Date: 07/06/2026
CAL FTL 54-043

Subject: 5th Generation Cascadia Headlamp Turn Signal Not Functioning

Model: 5th Generation Cascadia

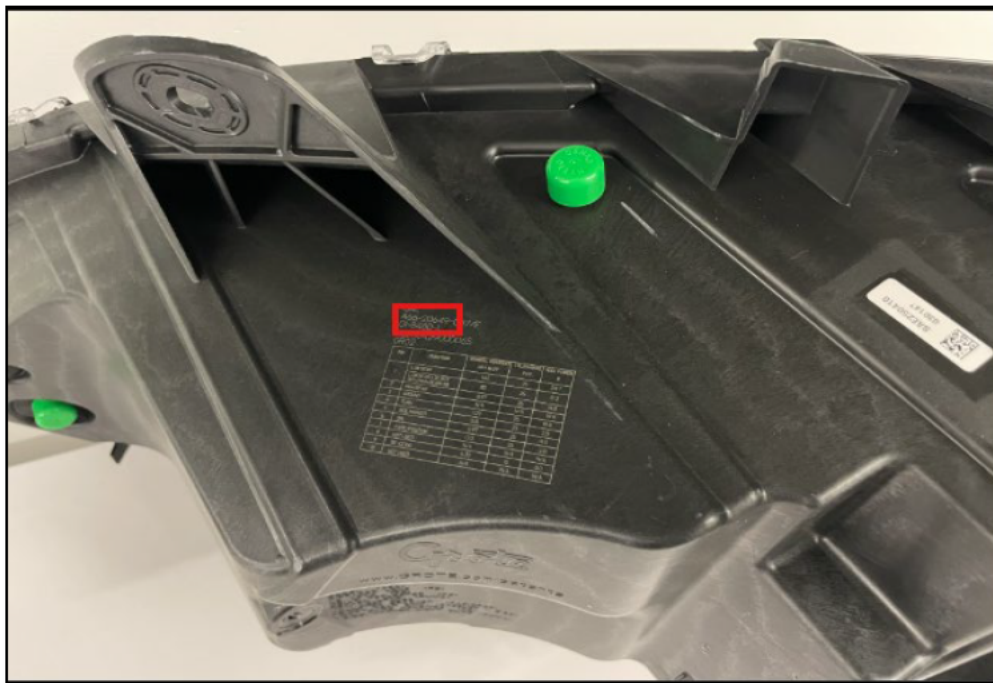
1. Park the vehicle on a level surface, shut down the engine, and set the parking brake. Chock the tires.
2. Identify the headlamp part number (A66-20649-XXX) by locating the part number stamp on the top of the headlamp housing.

3. If the part number is A66-20649-012 or A66-20649-013, it is a good headlamp, and no further action is required.
4. If the part number is prior to A66-20649-010 or A66-20649-011, it is a suspect part and should be replaced.
5. If the part number is A66-20649-010/011, follow instructions below to determine if the part is a suspect part.

- a. Located under the DTNA part number is the supplier part number (01-8480-X). To the immediate right of the supplier part number is a deviation number. If the deviation part number is PDNY01+D4, the part is good and does not need replacement. If the deviation number is PDNY01+C9, replace the headlamp.
